FINAL DRAINAGE REPORT

LOT 2 CROSSROADS MIXED USE FILING NO. 2 EL PASO COUNTY, COLORADO

Project #18-005
PCD Filing No.: PPR2311

PROJECT NO. 18-005	SCALE: HORIZONTAL: 1"=60' VERTICAL: 1"=5'	DATE: 05/31/2023
DESIGNED BY: TAU	DRAWN BY: TAU	CHECKED BY: VAS
SHEET 1 OF 1		FDM

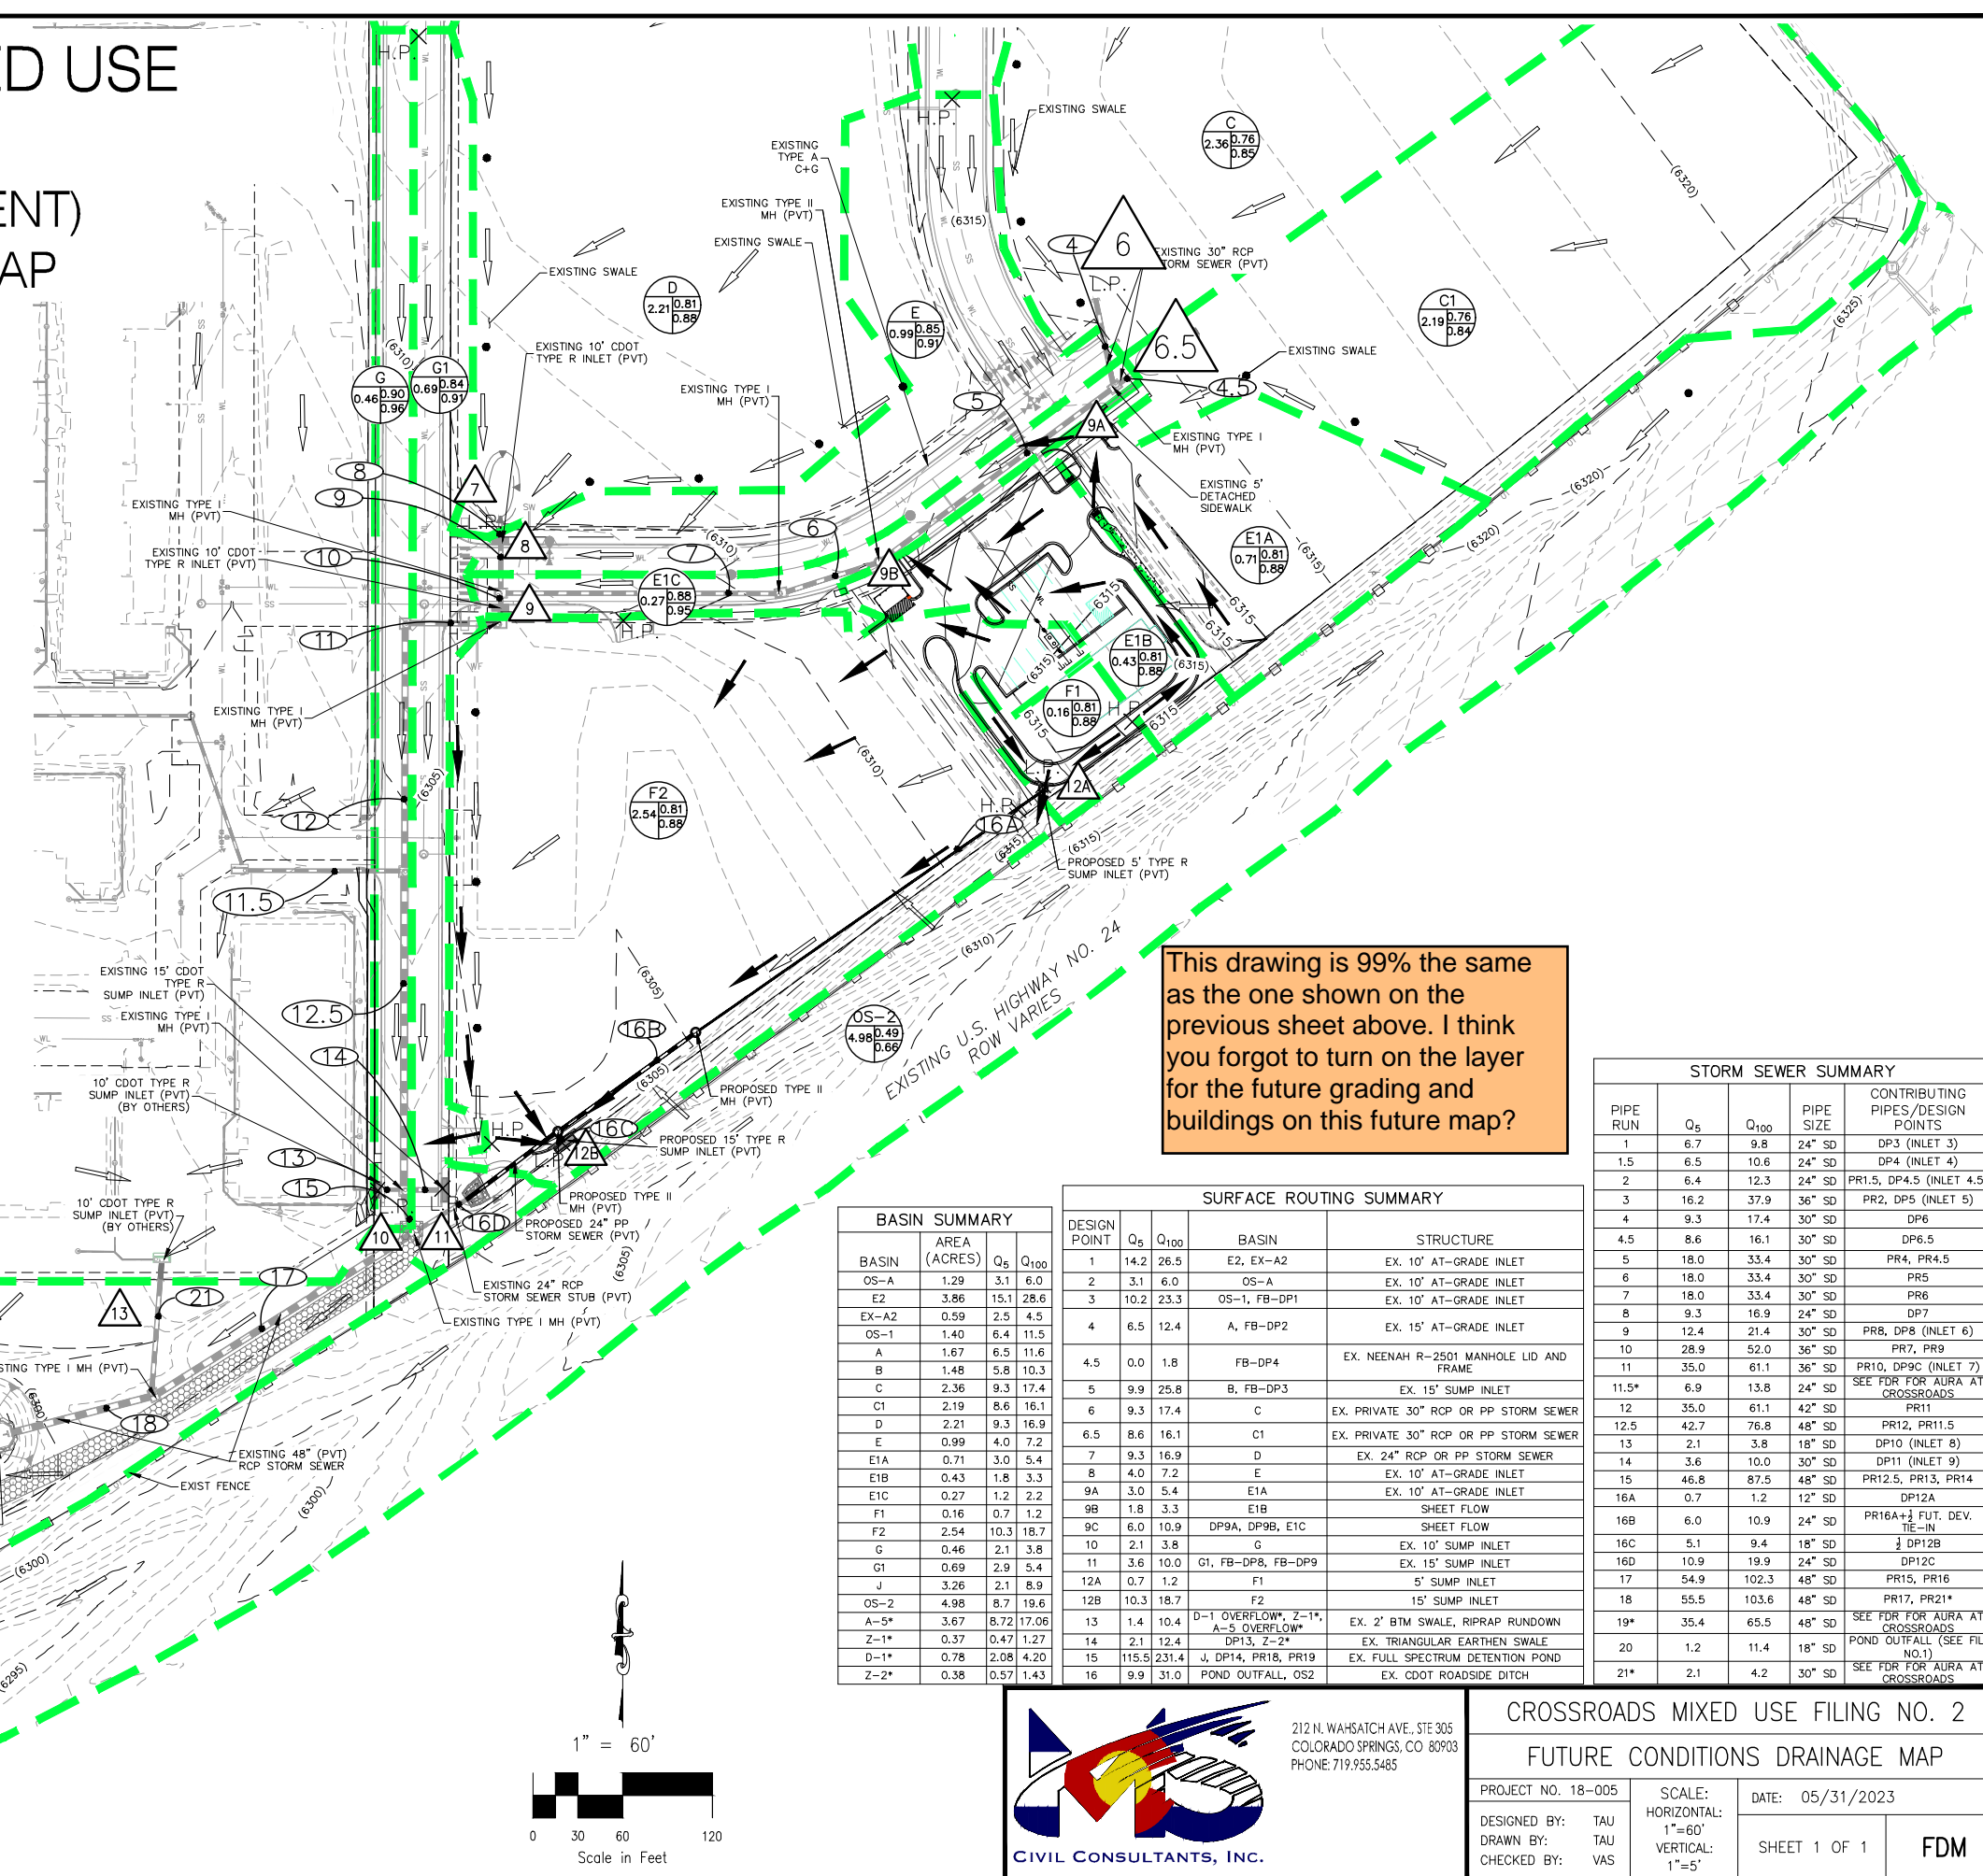
This drawing is 99% the same as the one shown on the previous sheet above. I think you forgot to turn on the layer for the future grading and buildings on this future map?
